Windfall/Zelman #1 DIW ~ Permit # PAS2D020BCLE

Zone of Endangering Influence Calculation

Comment: The Zone of Endangering Influence (ZEI) Calculation conducted by the EPA is not realistic based on the presence of nearby non-transmissive geologic faults. Use of the ¼ mile fixed radius Area of Review should be deemed to be unacceptable.

Zelman #1 Disposal Injection Well Estimated Zone of Endangering Influence (ZEI) Assuming Nontransmissive Faults

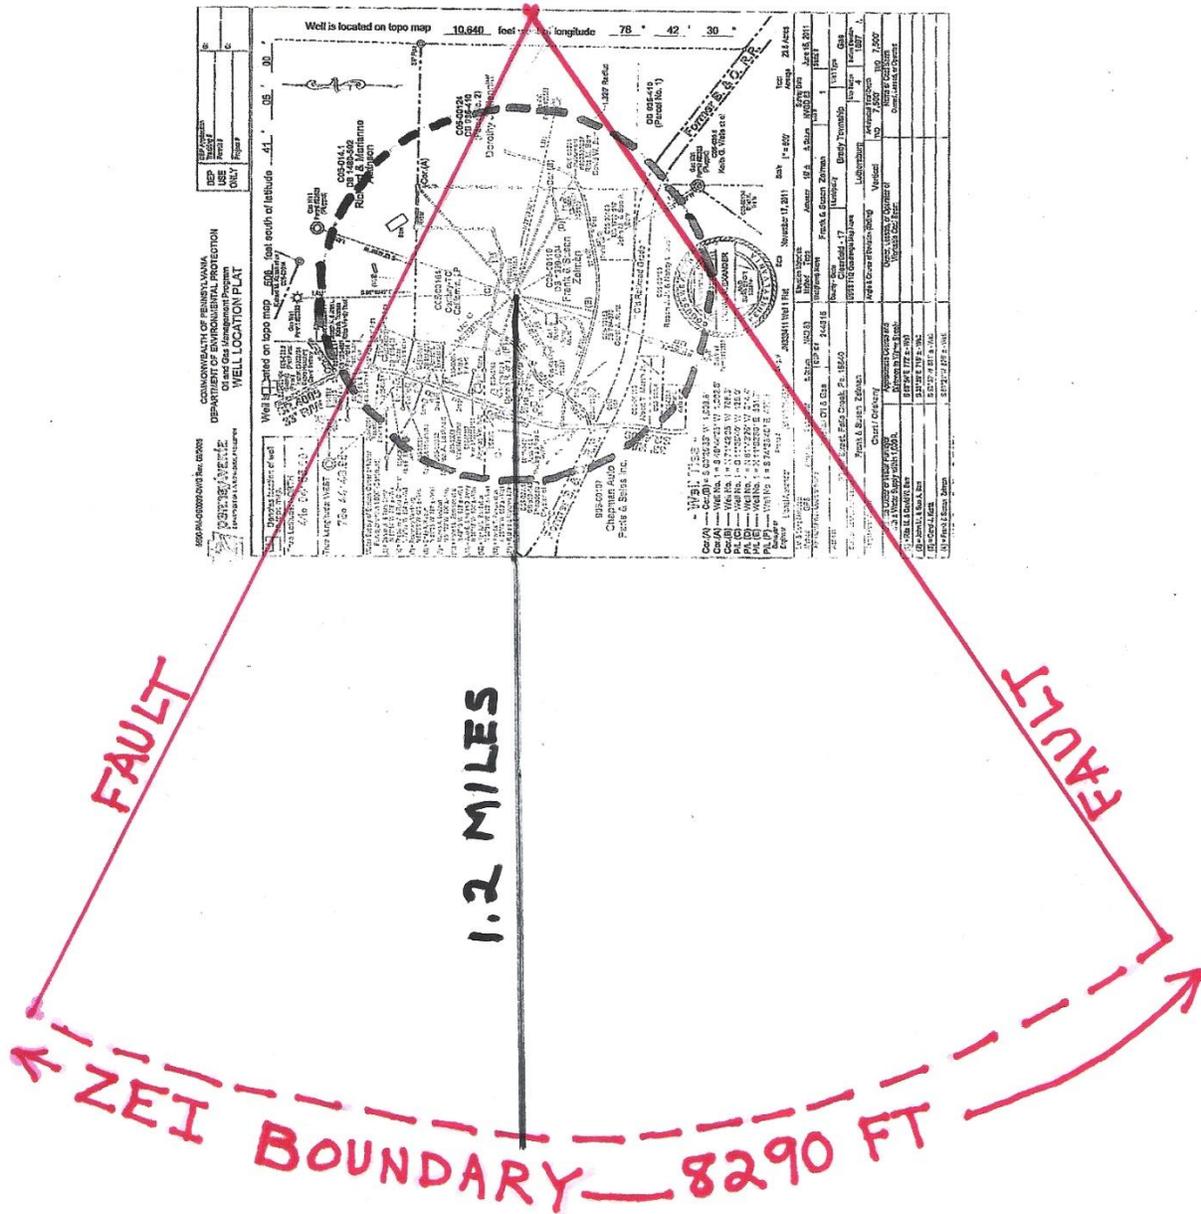
To estimate a better ZEI, one could approximate the nontransmissive faults shown on the map submitted by Windfall with their application with two straight lines which form a V-shape. The point of the V would be just to the east of the DIW. Therefore, for any liquid to escape from the injection zone, it must all pass through the opening at the wide end of the "V". Chances are that the ZEI is going to have a shape similar to the sector of a circle with an angle of approximately 60 degrees.

The flow through the rounded end of a sector-shaped ZEI with impenetrable straight sides would have to be equal in quantity to the flow through a ¼ mile radius circular ZEI for an equivalent DIW in an isotropic injection zone. Since pressure at both ZEI boundaries must be the same, and since the thickness of the injection zone is the same, the length of the curved end of the sector-shaped ZEI must be the same as the circumference of the ideal ¼ mile radius circular ZEI (8290 feet) in order to achieve the same amount of vertical area to transmit the same amount of flow at the same pressure in the injection zone.

The result, if this logical sequence is valid, would be that the EPA should establish an area of review that follows along the fault lines out to the point where the pressure drops low enough to follow a circular curve over to the point on the other fault with the same pressure.

If an equivalent substitute for the ¼ mile Area of Review is required, and the equivalent substitute is to be the sector of a circle with impenetrable straight sides intersecting at a 60 degree angle, the length of the sides would have to be 6 times ¼ mile which equals 1½ miles. The sector would be 1/6 of a full 360 degree circle. For the curved end to have the same length as the complete circumference of a smaller circle, the radius of the sector would have to be 6 times as long as the radius of the full circle. Refer to the attached diagram.

According to the diagram, USDWs located up to 1.2 miles from the Disposal Injection Well would be endangered if they were deep enough.

Incidentally, the fluid pressure where the fault lines join together is probably going to be quite high if the fluid cannot escape through the faults.

The Atkinson water well (RMS 8-9-19) is located very close to the northernmost fault shown on the map, and possibly directly over that fault. Therefore, it would not be a surprise if this water well is contaminated by methane or brine as a consequence of high pressure caused by the injection operation.

Also, the plugged Carlson gas well (Permit # 20341-P) would be located in the larger ZEI. This well is famous throughout the neighborhood for the fumes and/or methane that it emits in spite of being plugged. One would conclude that contamination of nearby drinking water aquifers is likely to occur because the casing cement and plugging of this well are suspect.

Attachment "M" Construction Details -subsurface Zelman#1 Injection Well ZELMAN WELLBORE SCHEMATIC

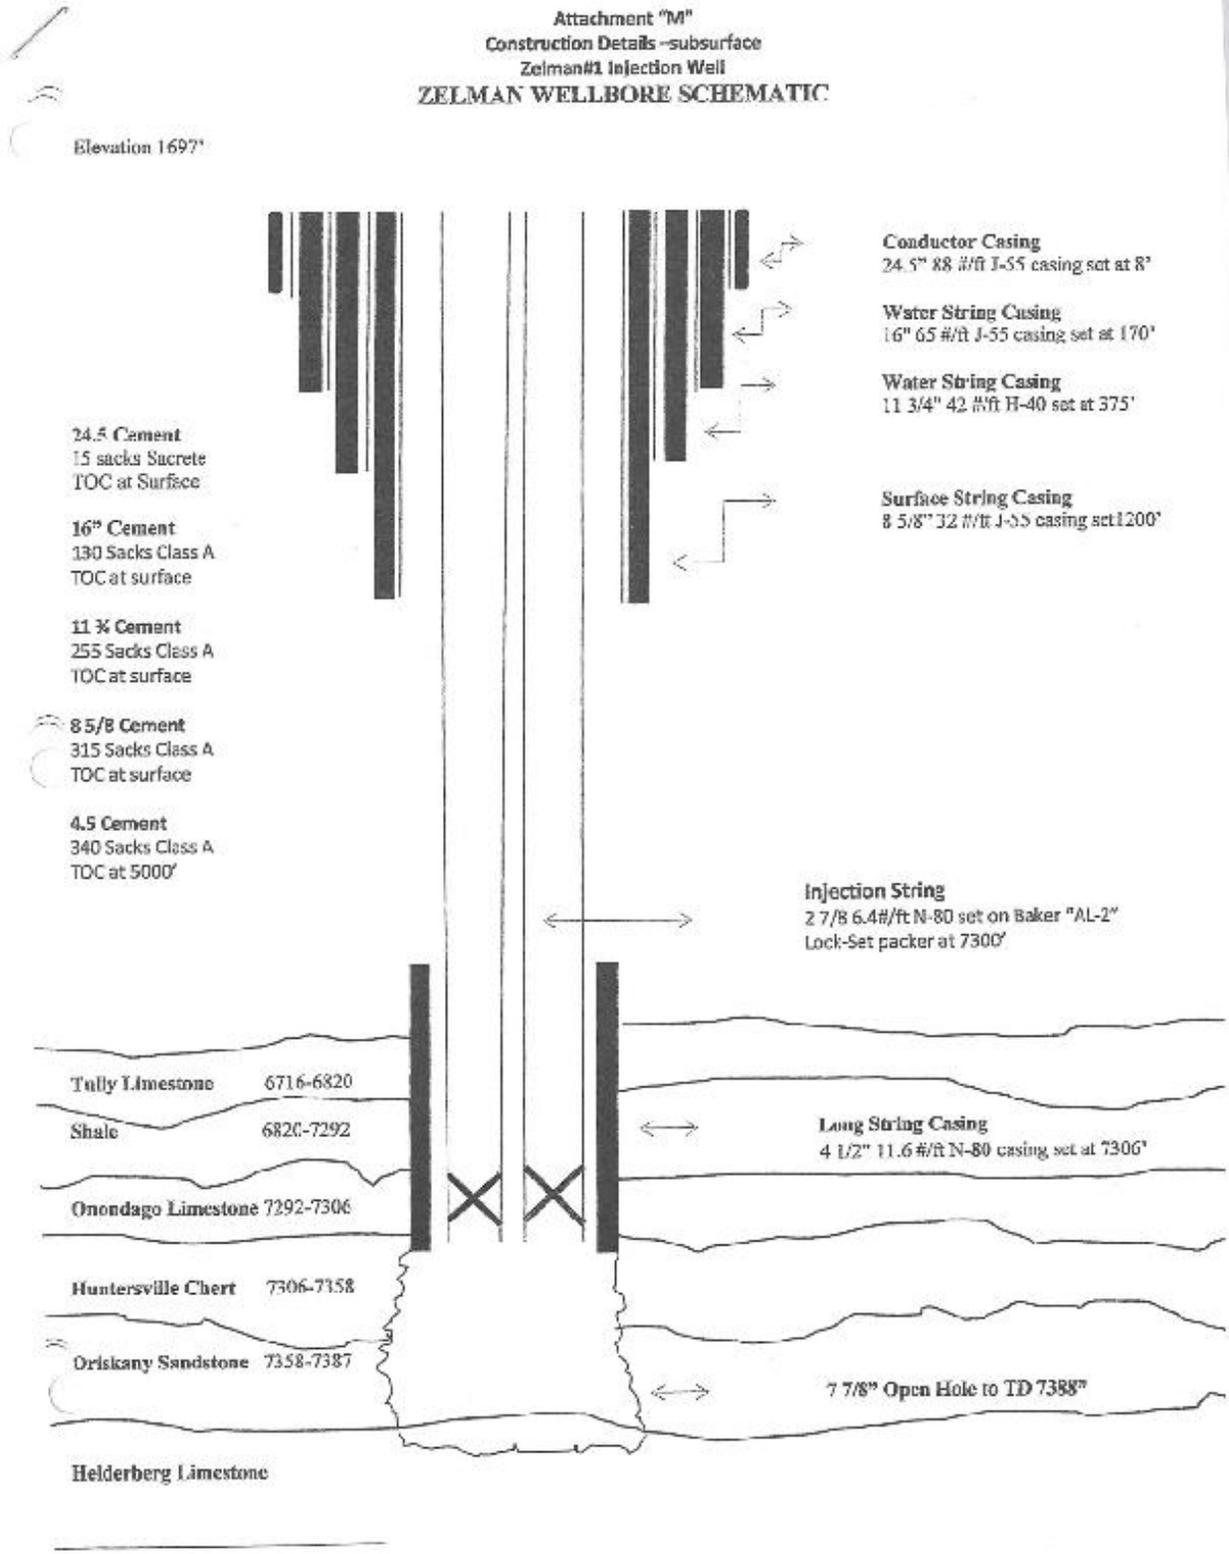
Comment: The draft permit (see attachment #1) specifies a simpler casing and cementing system than what was proposed by Windfall Oil & Gas in their permit application (see attachment #2). The EPA should change their casing and cementing requirement to include a 2nd ground water protective string of casing installed from the surface to a depth of 375 feet and cemented back to the surface.

In my opinion, the permit should require the Zelman injection well to be constructed according to the proposed casing and cementing plan which has 5 telescopic layers of casing outside of the injection tube as opposed to the draft permit plan, which has only 3 layers of casing outside of the injection tube.

The Atkinson water well driller said that they have to worry about the injection well taking their water. First, the DIW driller would install the 170' ground water protective string as specified in the draft permit. Then when he drills through the Atkinson's aquifer and continues drilling to a depth of 1000', that hole could drain the aquifer.

It would be better if the DIW driller drilled down through the second aquifer until a structurally intact rock layer is encountered. Then he should stop drilling, install a casing and seal around the casing with cement. Then he could continue drilling with a smaller bit without draining water from the second aquifer.
